**12 – 24 Stanley Street, Kogarah**

## **BCA Assessment Report**

### **Report 2017 / 3258 R1.1**

**Revision No:** R1.1  
**Date:** 26<sup>th</sup> April 2018  
**Revision Details:** Updated BCA Report for DA Submisison  
**Author:** Joshua Hawke  
**Verifier:** Andrew Rys

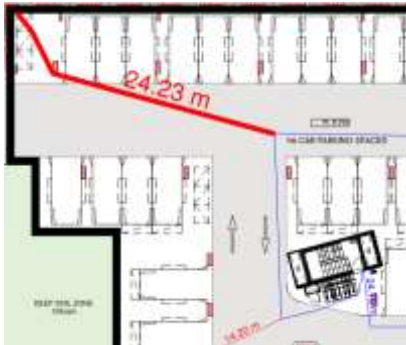
3.	D1.6	<p>Currently within the basement levels access is hindered by carspaces.</p>  <p>Within the BOH area on the ground floor the door opens over the path an</p>	<p>All paths of egress are required to be documented as no less than 1000mm to allow a compliant path of travel to an exit.</p>

<p>encroaches within the 1000mm path of travel</p> 	
4.	D2.20	<p>Currently the doors / gates providing discharge onto Stanley Lane swing in the direction that impedes egress.</p> 	<p>An amended drawing is required to be provided to the certifying authority for review demonstrating a compliant swing of door.</p>

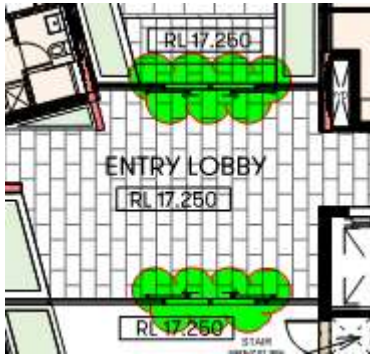
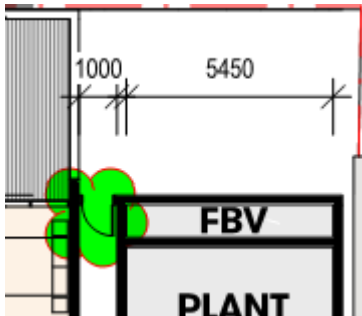
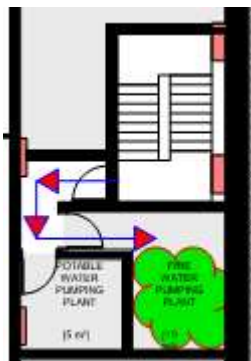
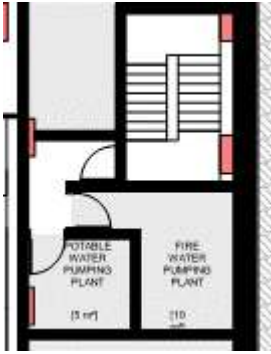
5.	E1.4	<p>Currently the majority of the fire hose reels are located greater than 4m from exits</p> 	<p>All fire hose reels are to be documented within 4m of exits with amended drawings to be issued to the certifying authority for review.</p>

6.	F2.1	<p>A common facility for maintenance workers has not been provided on or near ground level</p>	<p>Provisions of a facility for employees containing a closet pan and wash basin is required to be incorporated at or near the ground level and accessible to employees without entering a sole occupancy unit.</p> <p>The facility is required to be provided as the development consists of more than 10 SOUs.</p> <p>The provided facility is required to be compliant with the requirements of access provisions and be designed to incorporate elements of clause 15.2.8 of AS1428.1-2009</p>
